**EVAPOTRANSPIRATION COVER FOR THE 92-ACRE AREA
RETIRED MIXED WASTE PITS**

**Area 5 Waste Management Division
Nevada National Security Site**

INTERIM CQA REPORT

June 20, 2011

Drawing No. 10088-C-1006: Updated control points affected by changes to drawing stated above (attached).

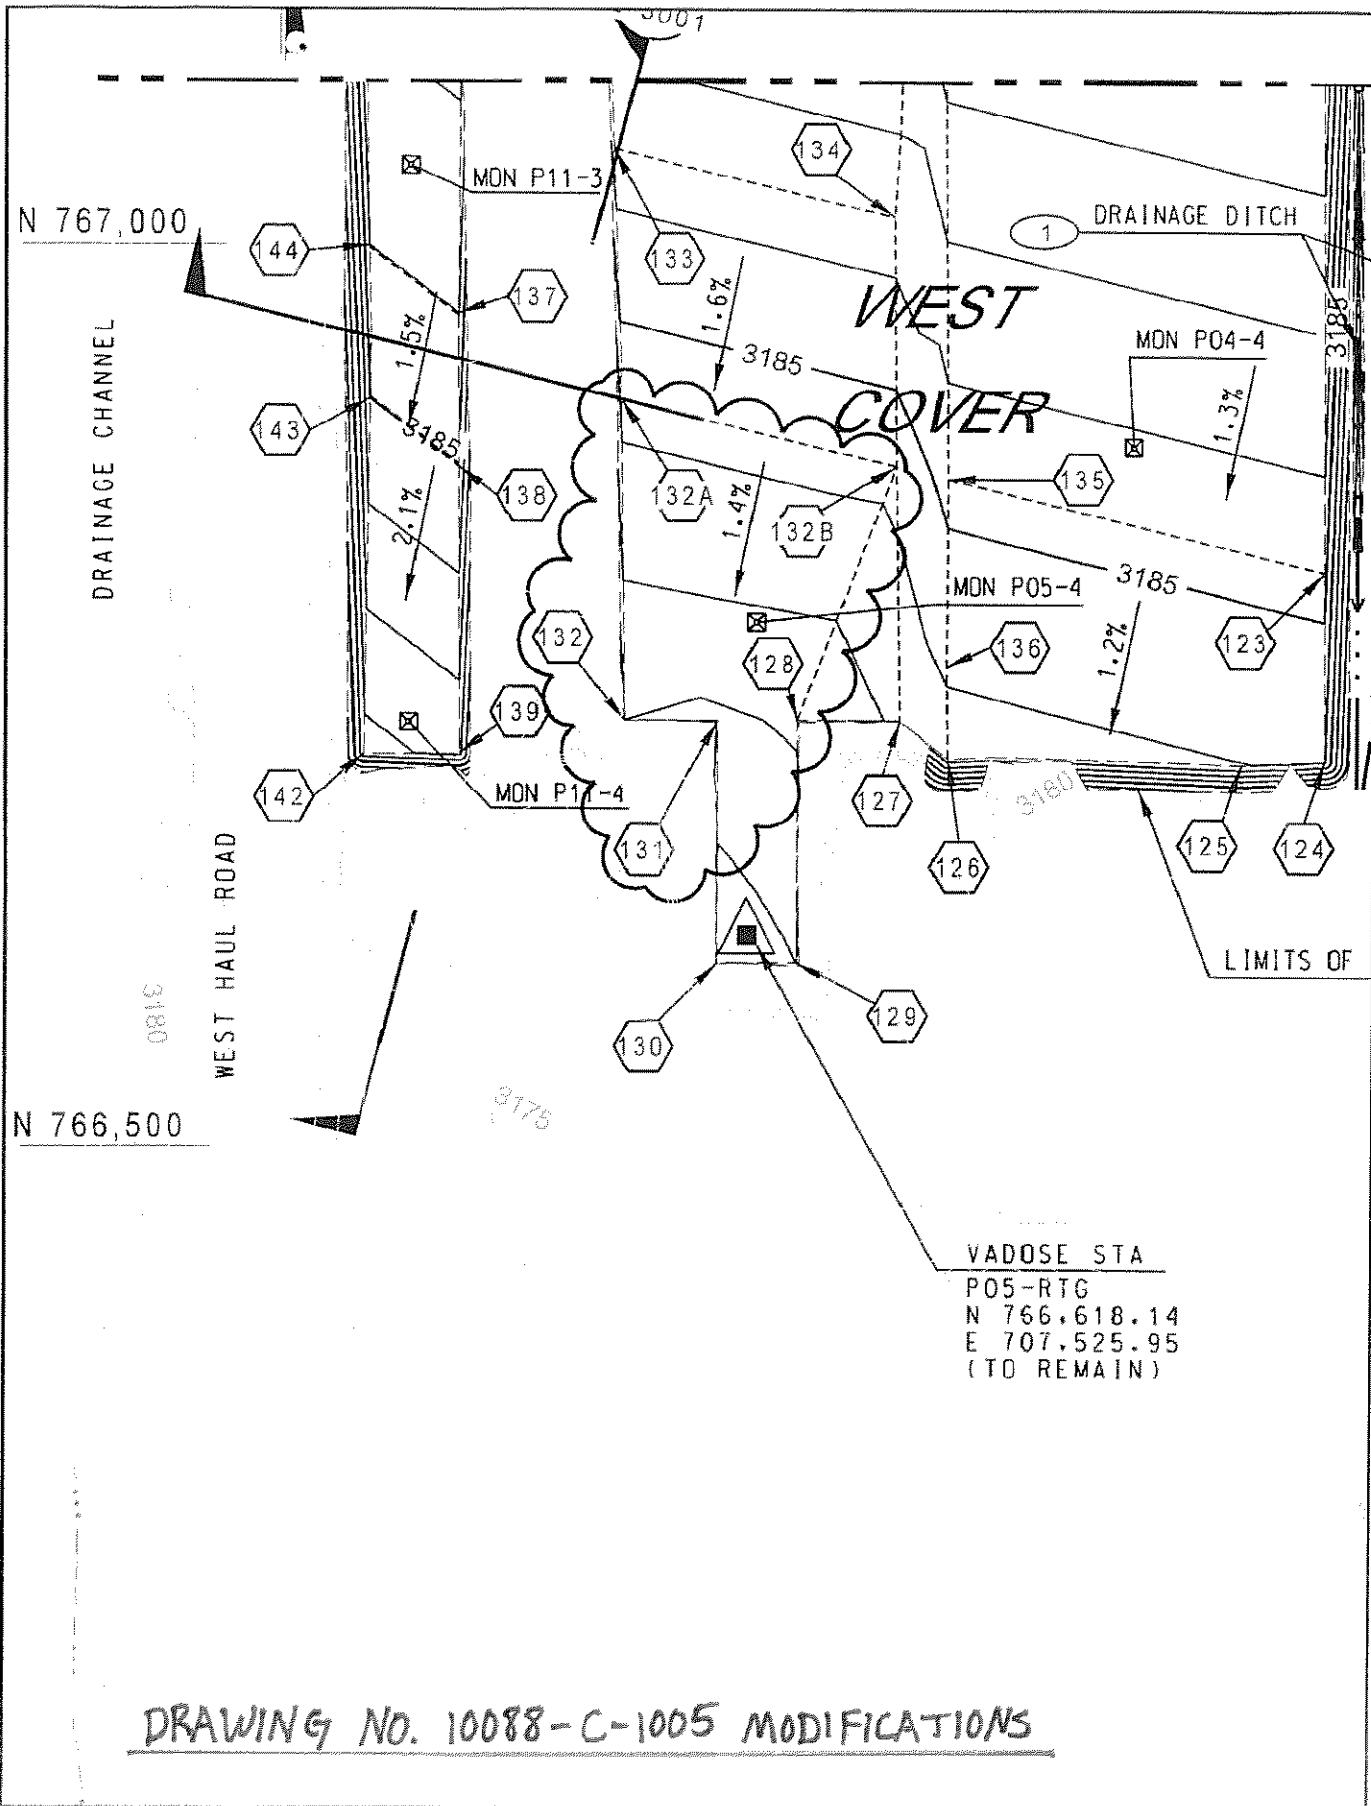
Drawing No. 10088-C-1005: Modified cover grading over southwest portion of West Cover P05 per updated information from the field (attached).

Drawing No. 10088-C-1005: Revised swale grading must be modified at project completion to reflect changes.

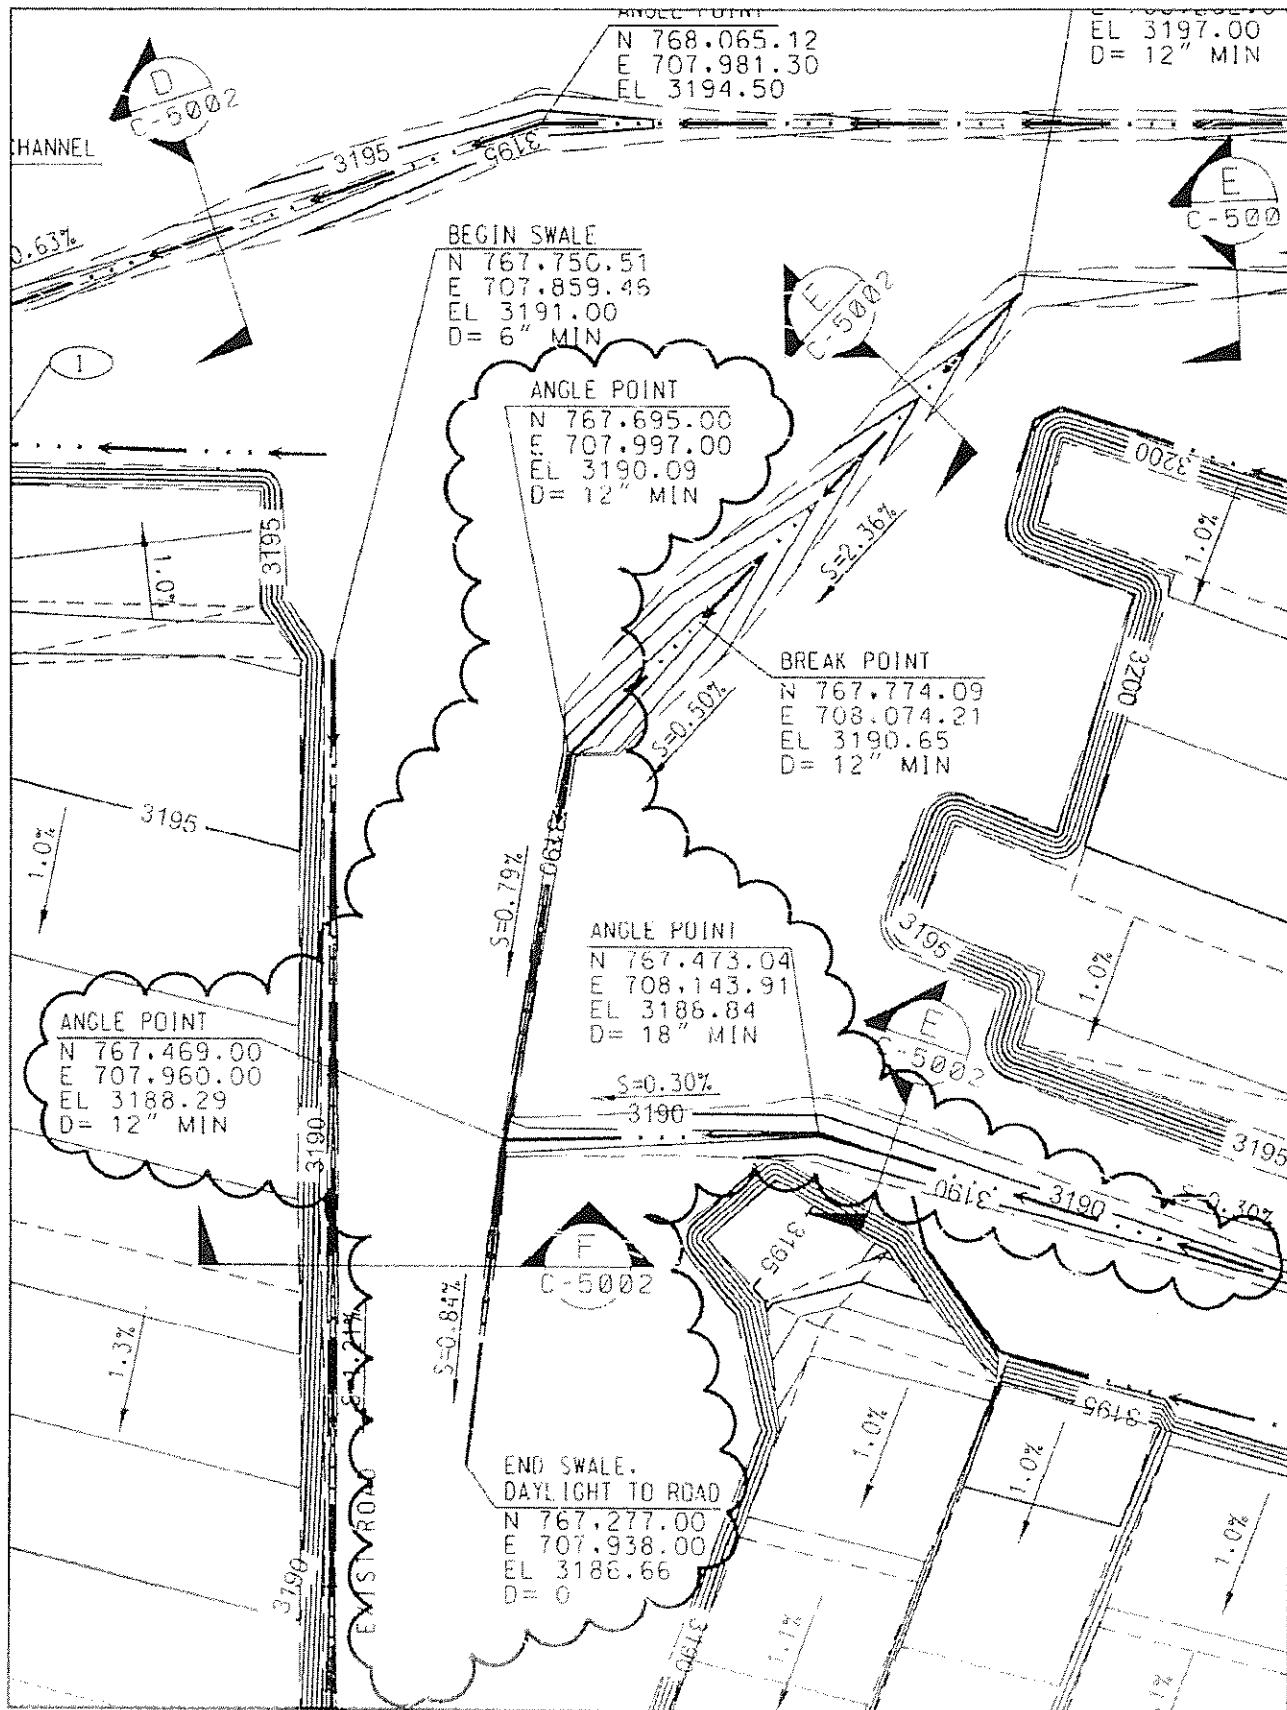
Drawing No. 10088-C-1004: Revised swale grading must be modified at project completion to reflect changes.
